SUBJECT: Tentative Map (P-8933)

LOCATION: Northwest corner of Mack Road and Franklin Boulevard

STAFF REPORT AMENDED 3-13-80
CITY PLANNING COMMISSION

- APPLICATION:
1. Environmental Determination
 2. Tentative Map to divide 20.8 acres into 7 parcels
 3. Special Permit to develop 304 condominium lots (P-8933)

Exhibit "A"

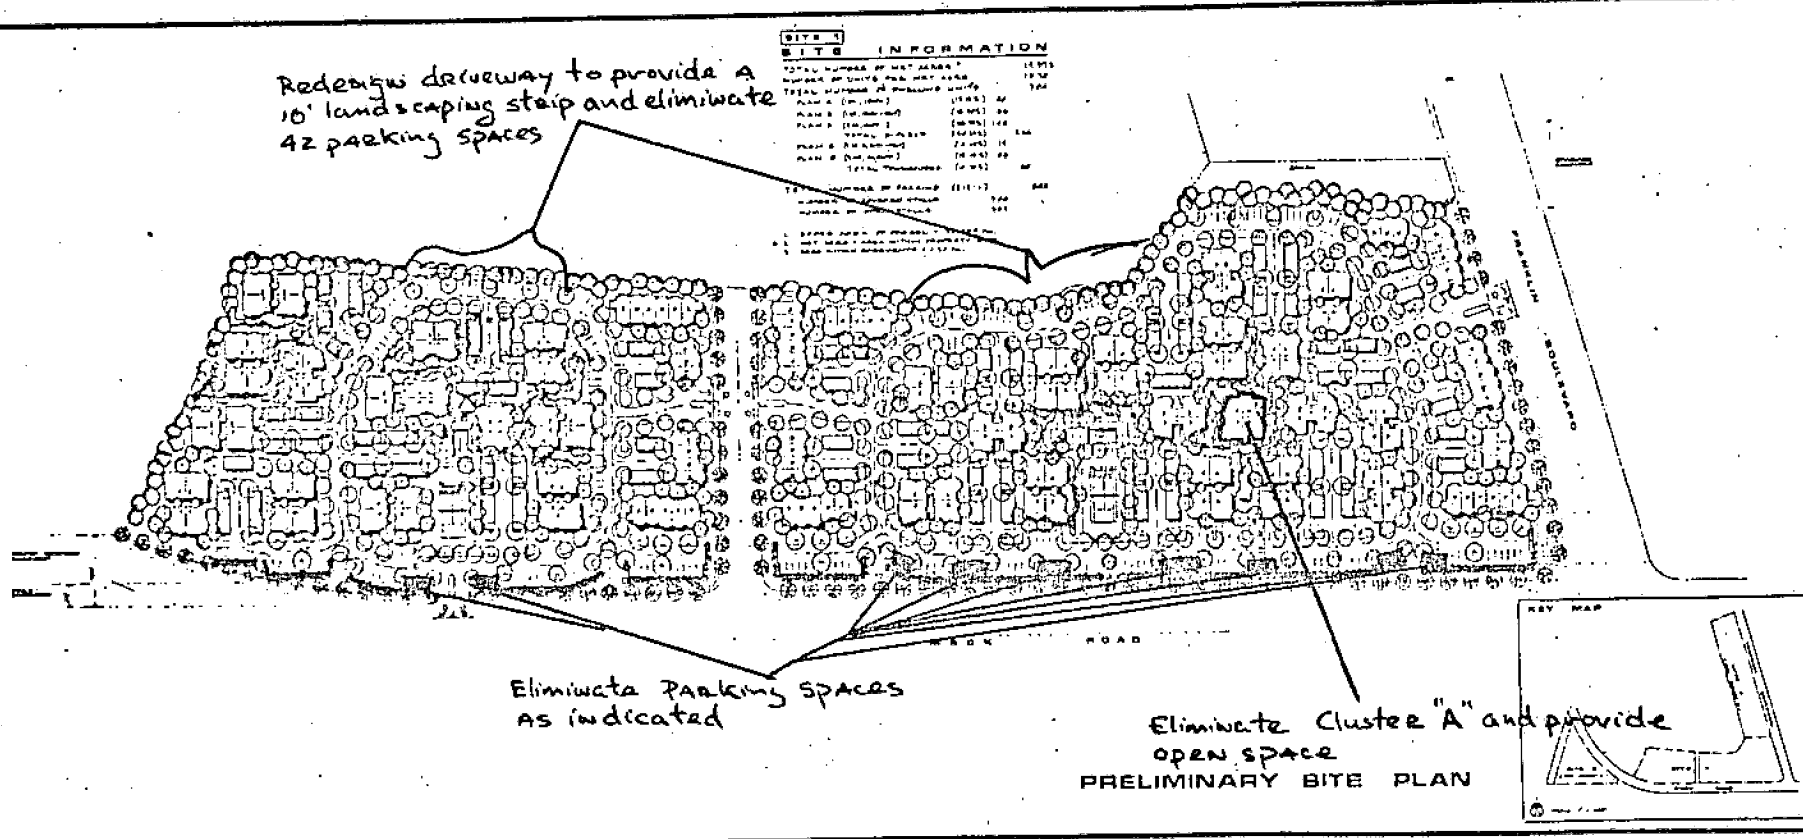
Redesign driveway to provide a 10' landscaping strip and eliminate 42 parking spaces

Eliminate parking spaces as indicated

Eliminate Cluster "A" and provide open space
PRELIMINARY SITE PLAN

- 1. The applicant shall redesign the northern portions of the main driveways to provide a 10' landscaping strip adjacent to the northern property line. This redesign shall include the elimination of 20 spaces on the western portion and 22 spaces on the eastern portion. In addition, the applicant shall shift the adjacent residential clusters north so as to provide more open space within the project.

- 2. The applicant shall eliminate those parking spaces adjacent to Mack Road as indicated in Exhibit "A".
- 3. Four units within Cluster "A", as indicated on Exhibit "A", shall be eliminated in order to provide additional open space and landscaping around Cluster "A".
